IDAP REPORT

Property:	19 South Street, Strathfield Lot 65 in DP8778 DA 2021/276
Proposal:	Construction of a two (2) storey dwelling house on a heritage item with basement level, in-ground swimming pool, attached cabana and ancillary landscaping.
Applicant:	Platform Five Design
Owner:	C & S Wang
Date of lodgement:	20 October 2021
Notification period:	1 November – 15 November 2021
Submissions received:	One (1) written submission received
Assessment officer:	L Gibson
Estimated cost of works:	\$2,382,703
Zoning:	R2 – Low Density Residential - SLEP 2012
Heritage:	Yes - Item I196, Georgian revival house and garden under Schedule 5 of the SLEP, 2012
Flood affected:	No
Is a Clause 4.6 Variation Proposed:	No
RECOMMENDATION OF OFFICER:	APPROVAL

Figure 13: Curtilage Diagram from Conservation Management Plan Garden of A Heritage Item I196 (January 2021) by Patrick O’Carrigan + Partners P/L

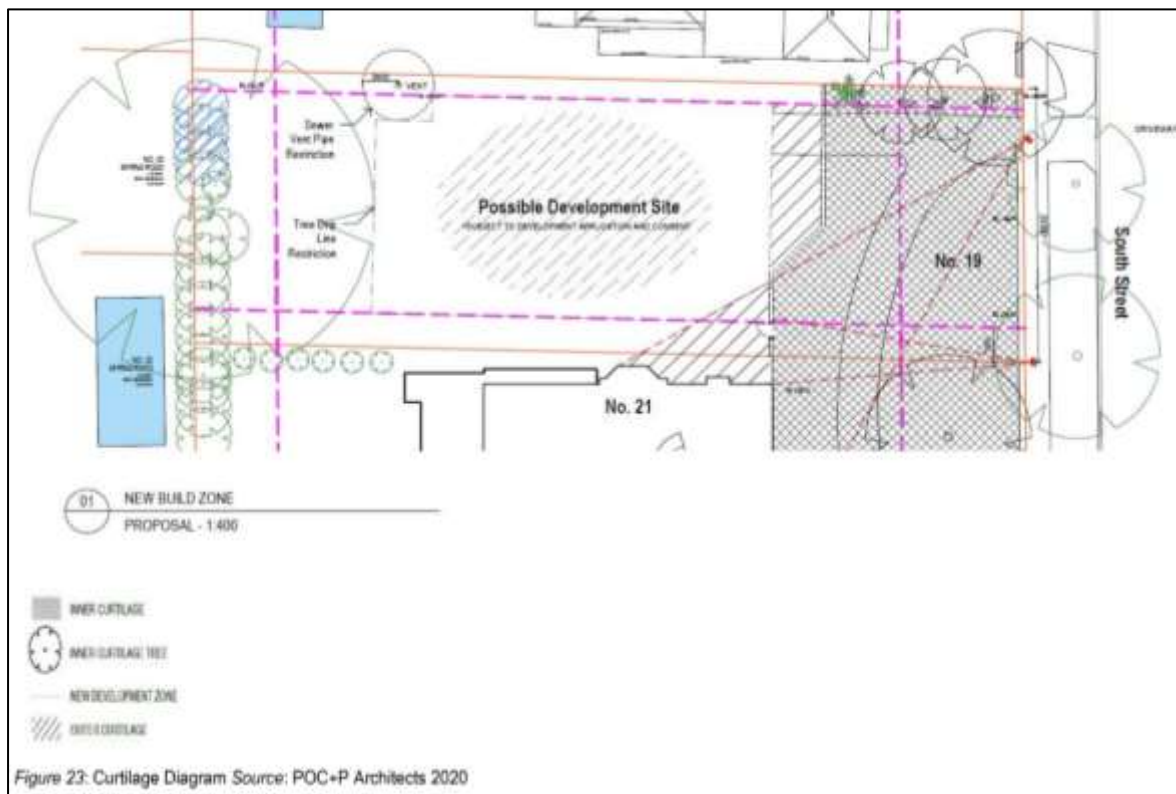
- D – The vestibule, porch and part of the dwelling are too far forward of the heritage item and is likely to further impact on the landscape, setting and curtilage by dominating and obstructing the views to the heritage dwellings northern wing from the public domain. Please see Attachment 1, which shows the setbacks to preserve the view line across the garden to the heritage listed dwelling (lot 65). It shows the view line is to the northern wing. (Shown in Figure 13 of this report).*

Amended plans were submitted during the assessment process to address the above concerns. The overall building has been shifted further west of the site toward the rear by a minimum 2.4m. This has achieved a more substantial front setback from the front property boundary and consequently a more generous curtilage to be retained around the heritage building. The front portico element provides a setback of 18.025m with the remainder of the dwelling further setback to a minimum of 20.226m from the front building line. There are therefore no encroachments within the view corridor.

In addition to the above, the proposed new dwelling has been scaled and sited in accordance with the curtilage diagram provided in the management plan below (Figure 13). The plans have been amended during the assessment process to increase the front setback provided by the new dwelling and ensure that the northern bay window to the heritage dwelling is clearly visible from the street (Refer back to Figures 4 and 5 which convey this view corridor and curtilage requirement in red dotted line).

Figure 14: Approved fence location between 19 and 21 South Street.

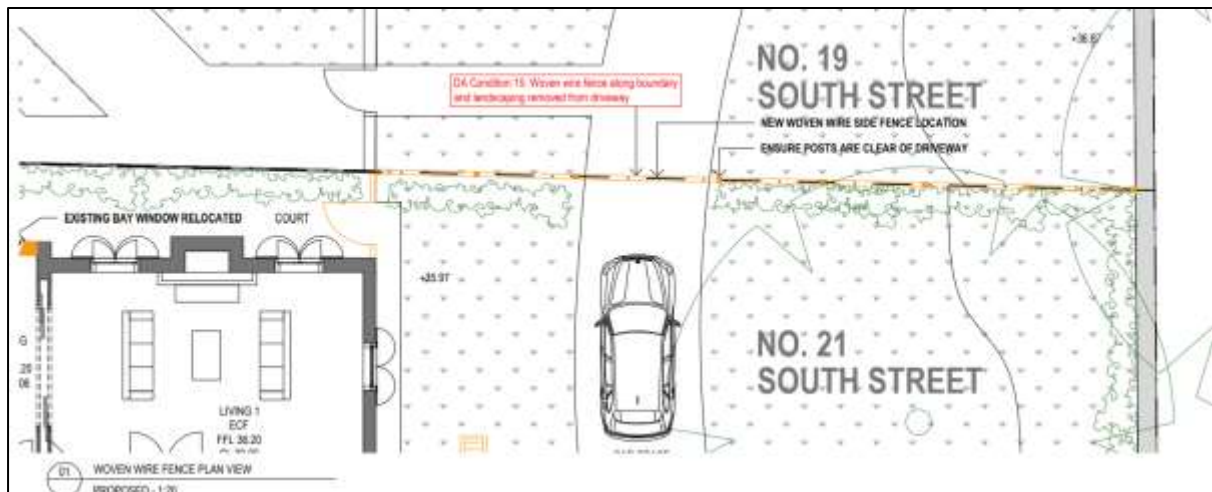
- 2) *Side Boundary Fence – concern is raised for the side boundary fence proposed between properties 19 and 21 South Street. A part of the application refers to this fence as a woven wire fence however other parts (including the landscape plan) refers to the fence as a 1800mm high fence. The fence (if approved as the later) will obscure views to the heritage listed dwelling.*

Assessing Officer's Comment: A condition of consent is recommended to ensure that the open wire woven fence be constructed to a height of no more than 1.5m forward of the front building line. This will ensure that views from the street to the heritage building are not obscured from view.

Figure 18: Shadow diagrams showing extent of overshadowing at winter solstice

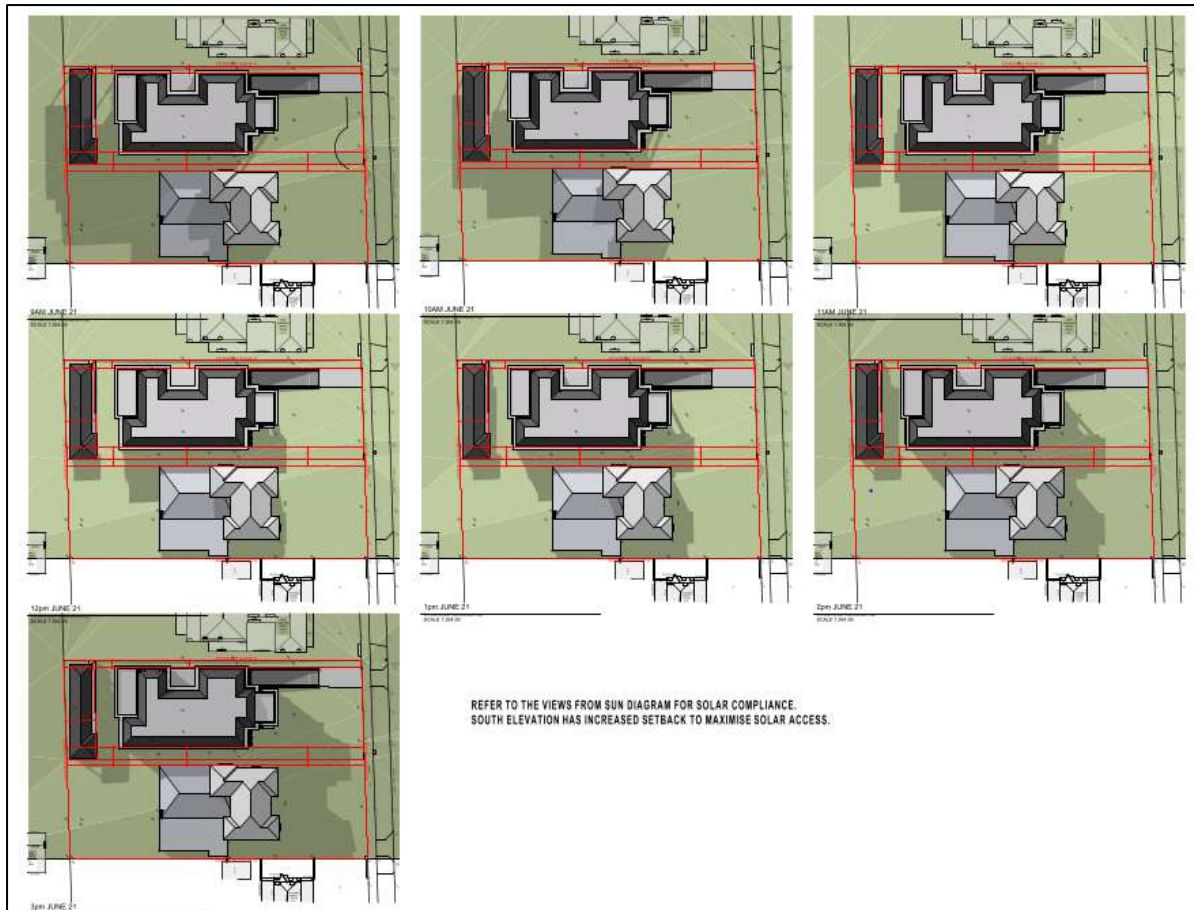
The site is provided with an east-west orientation resulting in an unavoidable degree of overshadowing to the southern adjoining heritage building. The application was accompanied by a series of shadow diagrams to demonstrate the impact of overshadowing to the southern heritage dwelling through the day (refer to Figure 18 below). As a result of the increased setback provided by the dwelling (through amendments to the previous design during the assessment process), solar access to the front living area of the heritage dwelling has improved.

The submitted shadow on elevation plans demonstrate that the southern adjoining rear living room will be most affected as a result of the proposal (refer to Figures 19 and 20 below). Notwithstanding this, the room is provided with western-oriented windows and will therefore be capable of receiving ample light through the day.

Figure 21: Proposed section plan showing basement heights.

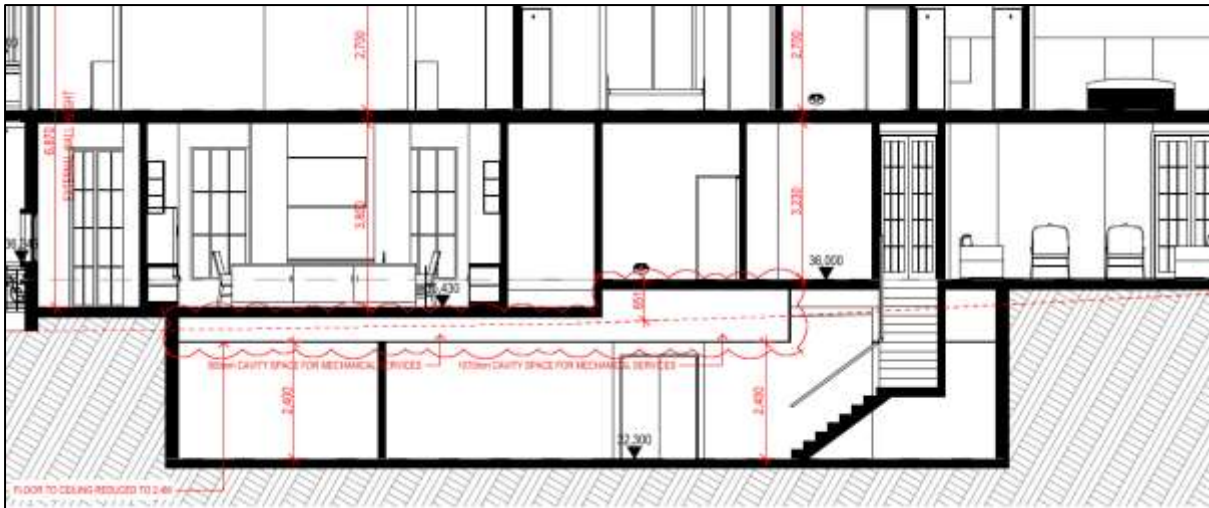
The proposed 3.5m floor to ceiling height of the basement results in excessive excavation on the site (refer to Figure 21 below). Excavation should be minimised where possible to minimise soil disturbance. Given that these spaces are not intended for habitable use, a condition of consent is recommended to ensure the maximum basement floor to ceiling height exceeds no more than 2.4m from the floor to ground floor level. This is inclusive of the cavity for mechanical services.

Amendments made in red on approved plans	All changes made in red on the approved plans shall be updated and shown on the Construction Certificate plans.
Basement Floor to Ceiling Heights	The basement floor to ceiling heights are to be reduced to a maximum of 2.7m (inclusive of mechanical services cavity).
Swimming pool and cabana	The swimming pool and cabana structures are to be deleted from the plan and reinstated with deep soil zone.

Figure 22: Proposed cabana structure and adjoining roof structure (cabana is to a height of RL39,093 AHD and roof structure extending across pool is to a height of RL38,950 AHD),

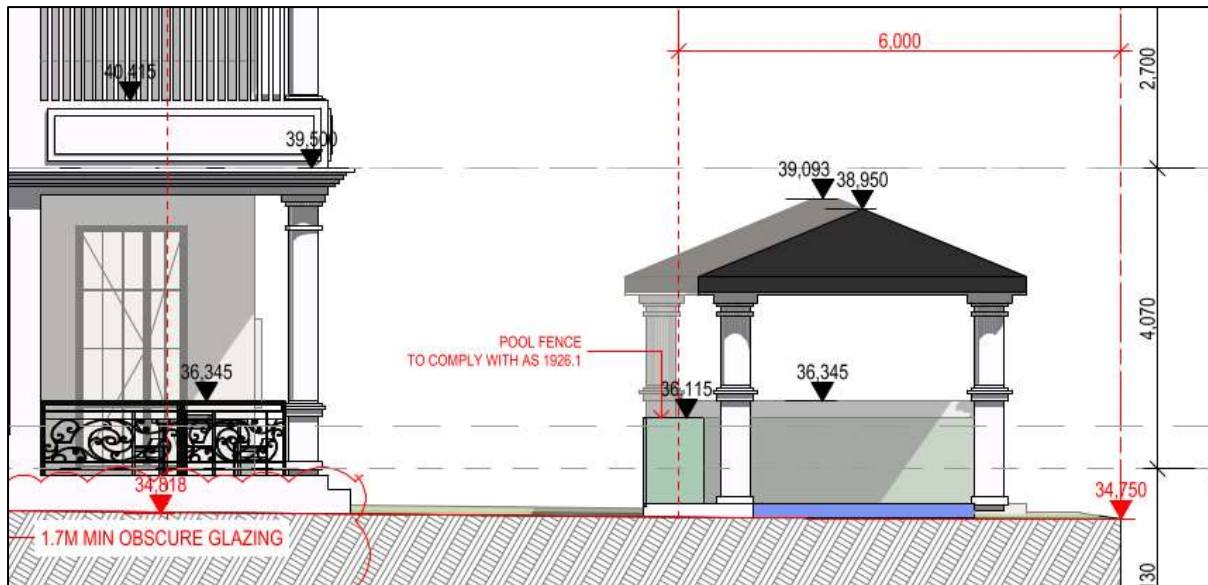
The proposed cabana and adjoining roof structure spanning across the swimming pool proposes a height of 4.12m (cabana) and 3.94m (pool roof). This exceeds the maximum 3.5m roof height permissible for outbuildings under Part A of the SCDP 2005 (refer to Figure 22 below). Whilst these structures are non-compliant, a condition of consent is recommended to delete these structures as they result in undue impact to the adjoining Sydney Blue Gum tree.

As the Sydney Blue Gum tree along the rear boundary is recommended for retention, the cabana and swimming pool structures are required to be deleted from the plans.
